Preliminary Consultation MONTGOMERY COUNTY HISTORIC PRESERVATION COMMISSION STAFF REPORT

Address: 25 Montgomery Ave., Takoma Park Meeting Date: 10/28/2020

Proposal: Accessory Structure Demolition and Construction (Retroactive)

Figure 4: Elevation of the proposed structure with the rear of the house (left) and the neighboring property (right).

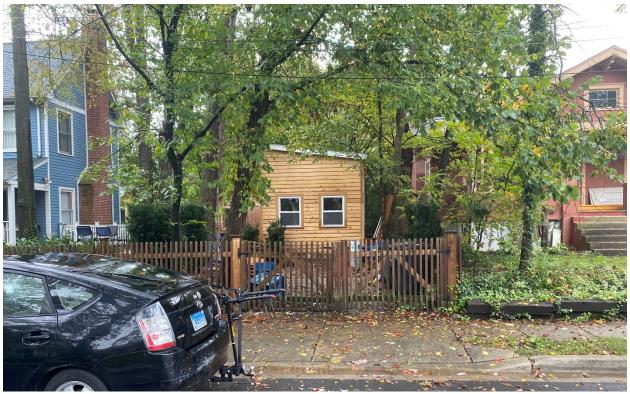
The applicant proposes to construct a new accessory structure on the property. The structure is under construction on the site, though work has been halted. The proposal will move the structure 5' (five feet) to the east, away from the property line, to meet minimum zoning requirements. The proposed structure measures 10.5' \times 19' (ten and a half feet by nineteen feet) and is clad in unpainted cedar siding and a shed roof. The roof measures 12' (twelve feet) above floor level on one side and 10' (ten feet) above floor level on the other, however, that is not the overall height of the structure. Because the structure is on concrete piers, the structure is an additional 8" -12" (eight to twelve inches) above grade. An accurate measurement of the total height above grade would be helpful to fully evaluate the proposal.

The structure has two one-over-one sash windows on the north (Montgomery Ave.) elevation. On the east elevation, there is a pair of French doors with four clerestory casement windows. The west elevation of the proposed structure is a blank wall and has no openings. Material specifications for the doors and windows were not included with the application, but based on observations at a Staff visit, the windows and doors appear to be vinyl.

Staff will next discuss form. Takoma Park is an eclectic District, with a range of architectural forms that contribute to the collective character of the neighborhood. The *Guidelines* support unique designs that are sensitive to and compatible with the "fabric of the community." While this proposed accessory structure is approximately the size of a small garage, the form is quite different. Simply detailed, one-bay, front gable garages are ubiquitous features within the district and tend to blend into the streetscape. This would

be the most compatible form to blend in with the surrounding streetscape. The form of this proposed structure is decidedly contemporary. The impact of this choice is augmented by the visible corner location. Staff requests feedback from the HPC as to the appropriateness of the form of the proposal.

Regarding materials, Staff finds that the proposed wood siding and architectural shingle roof are both materials that are compatible with the house and surrounding district. Staff finds that as a new accessory structure to a Non-Contributing resource, vinyl windows and doors are acceptable. The raw cedar siding may be the most visually jarring element of the proposal. This finish may be appropriate for smaller accessory buildings like garden sheds, but it stands in stark contrast to the painted stucco and clapboard (and fiber cement siding) in the surrounding streetscape, as illustrated in the figure below. Staff recommends the HPC, at a minimum, require a dark painted finish for the proposed structure. This type of finish will allow the structure to better recede into the surrounding streetscape.

- Changes to roof form from the shed/pent roof to a gable, or alternatively a steeper pent roof;
- Alterations to the fenestration pattern on the street-facing elevation so it more closely resembles a garage or shed (this may or may not include windows on the north elevation);
- Changes to the finish that would better blend into the streetscape;
- Relocation or reorientation on the lot would placing the proposed structure more than 10' (ten feet) from the western property line improve the relationship between the proposal and the surrounding streetscape?
- Any other revisions or alterations.

- Drawn to scale site plan that includes the side and front wall of the property at 23 Montgomery
- Drawn to scale elevations for all four (4) sides of the proposed structure, including total height above grade at each corner, and notes corresponding to proposed materials,
- Material specifications for the windows, doors, roof material, and fascia.
